Re: Indian Point Unit No. 2
Docket No. 50-247

Subject: Response to the Staff's Requests for Additional Information (RAI) Regarding the Steam Generator Tube Examinations conducted during Spring of 2000 Outage, and the Root Cause Evaluation of the Steam Generator Tube Rupture Event of February 15, 2000 (TAC No. MA8219)

Response to Questions Regarding Steam Generator Tube Examinations
Performed During Spring 2000 Outage

Consolidated Edison Company of New York, Inc.
Indian Point Unit No. 2
Docket No. 50-247
June 2000

Figure 16

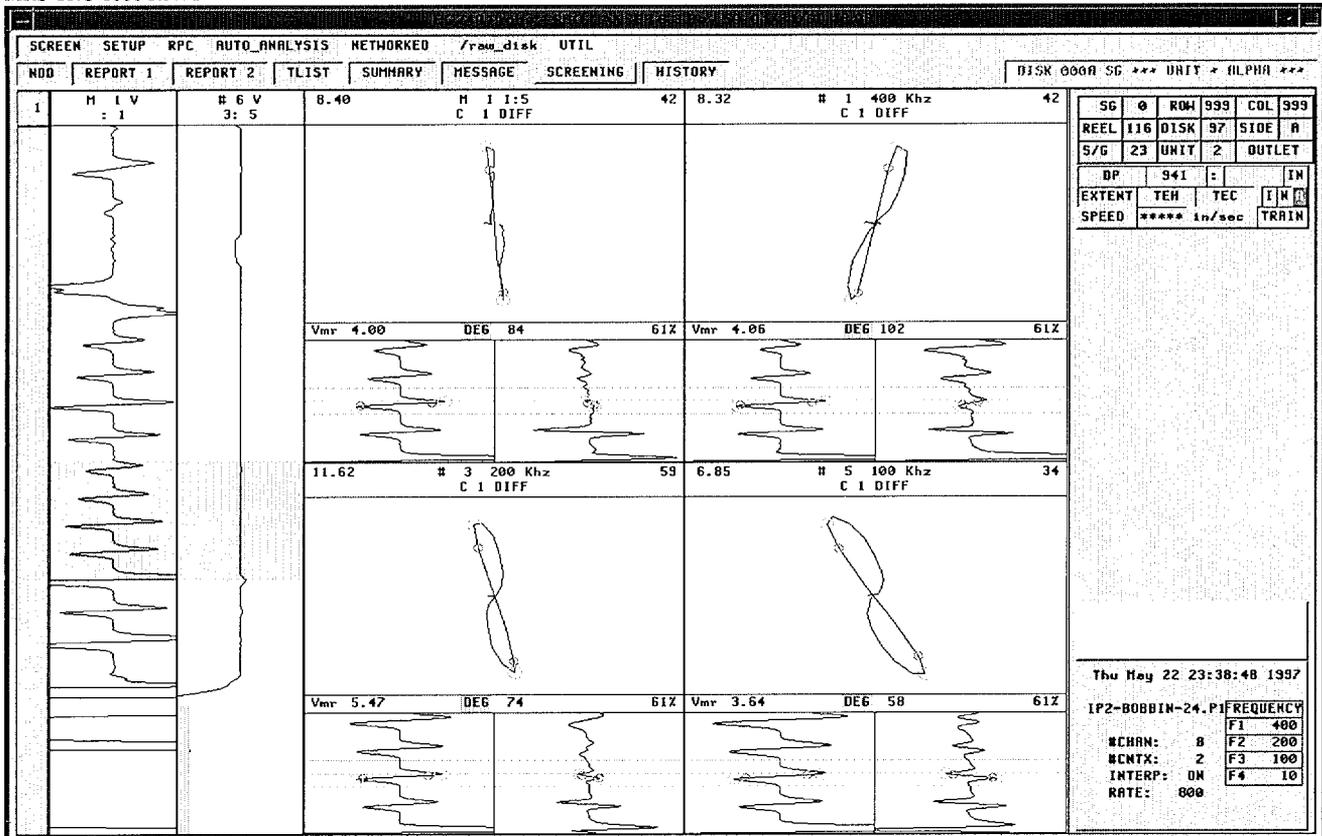
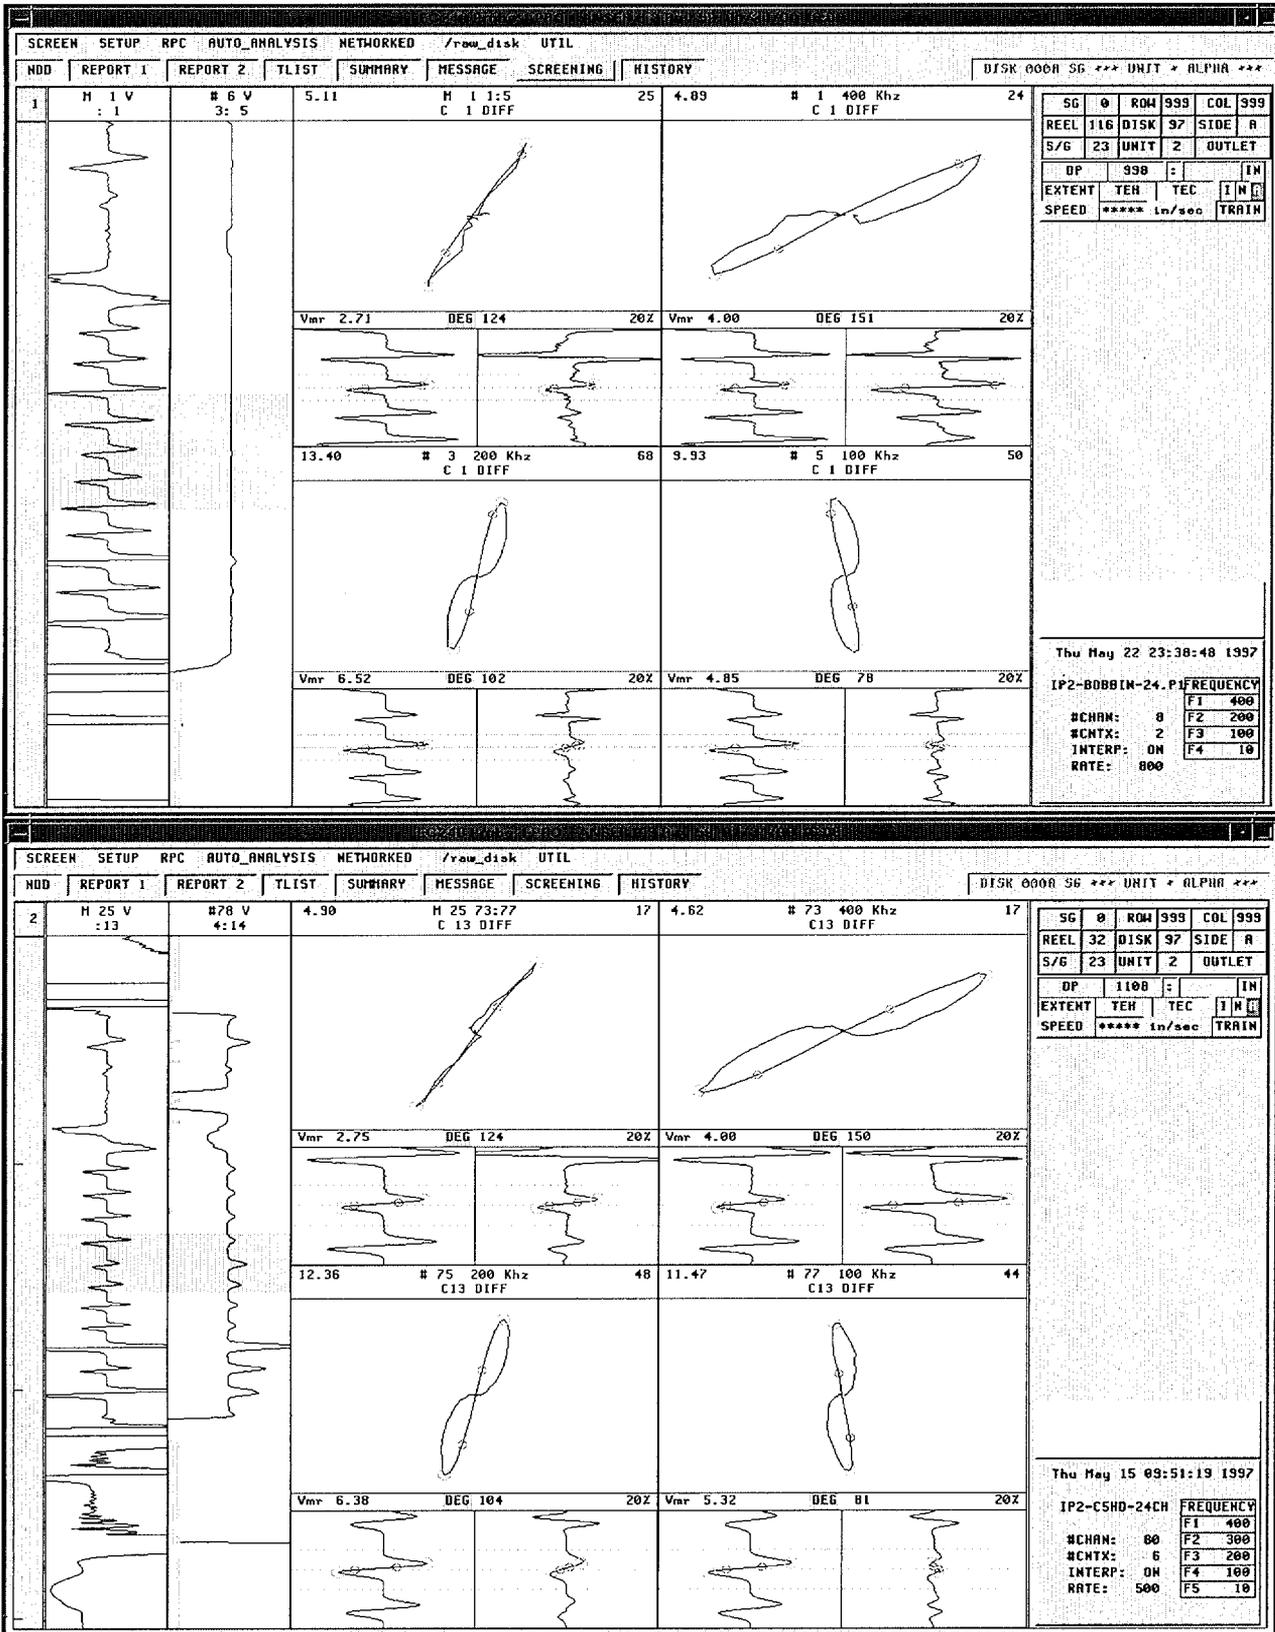
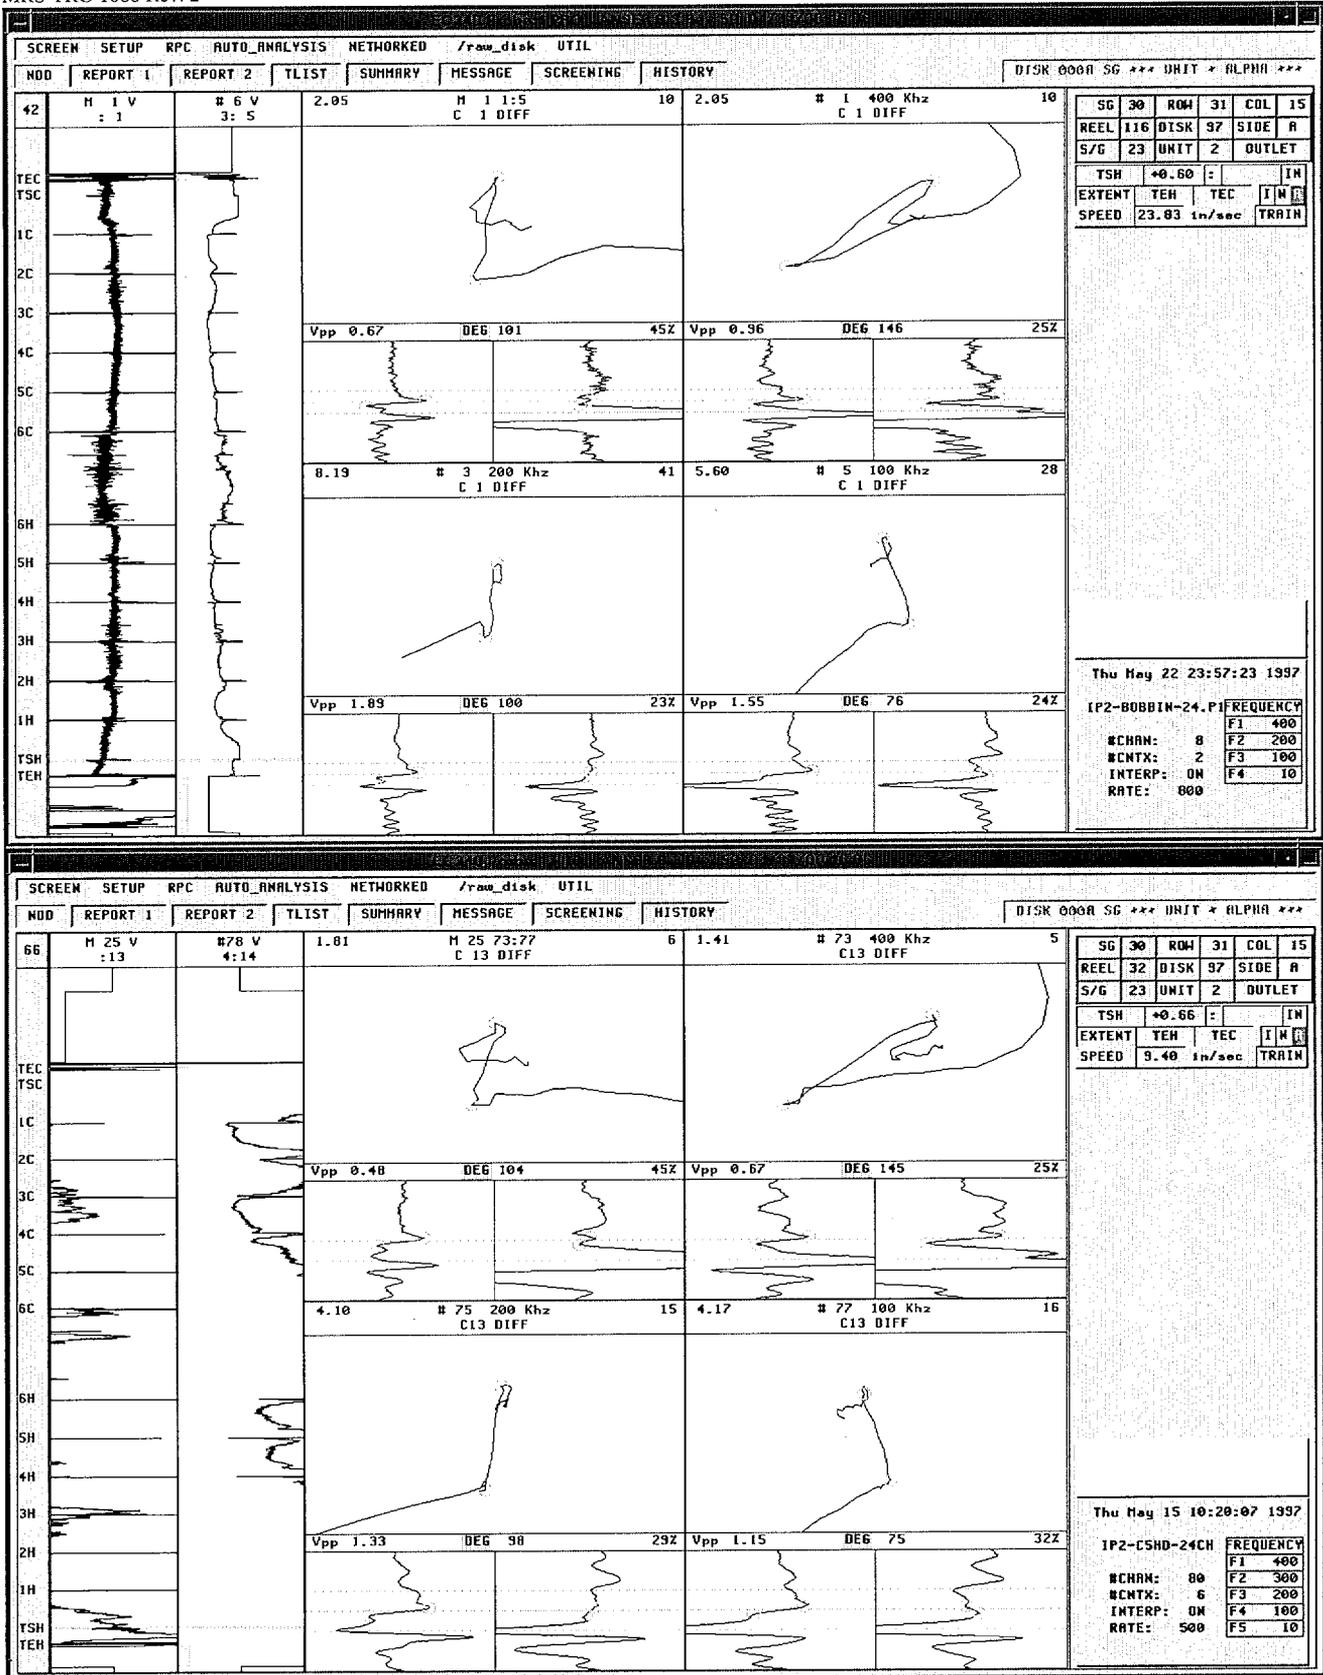
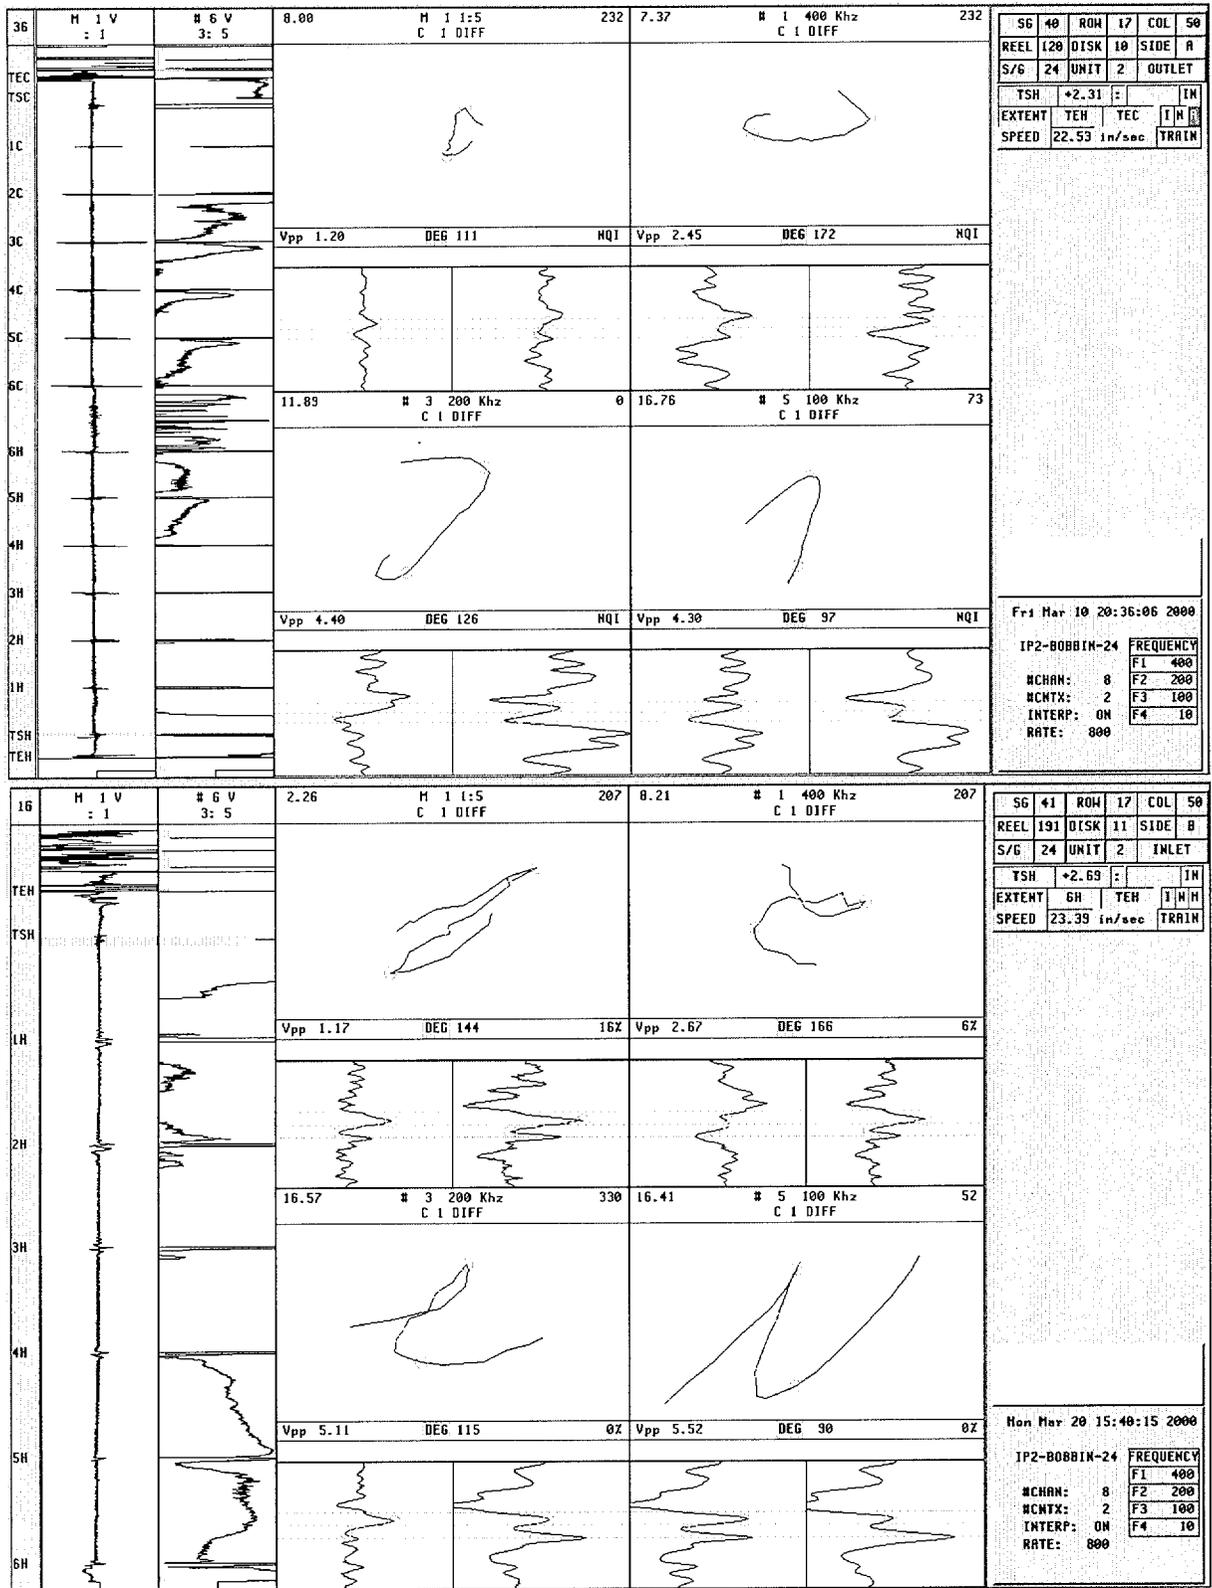
Provide the documentation of the site qualification review of the eddy current techniques applied during the 1997 and 2000 inspections.

Figures 16, 17, 18, and 19 document comparisons between the 700LLMC bobbin probe and the bobbin coils on the Cecco-5 probe from standard responses and a typical signal from Indian Point 2 field data. The results of this review show that there is equivalence between the two bobbin probes. **Figures 20, 21, 22 and 23** document comparisons between the 0.700 inch and 0.610 inch bobbin probes on typical signals from Indian Point Unit 2 field data. This shows, on a site-specific basis, that there is equivalence in terms of detection for signals > 0.5 Vpp.
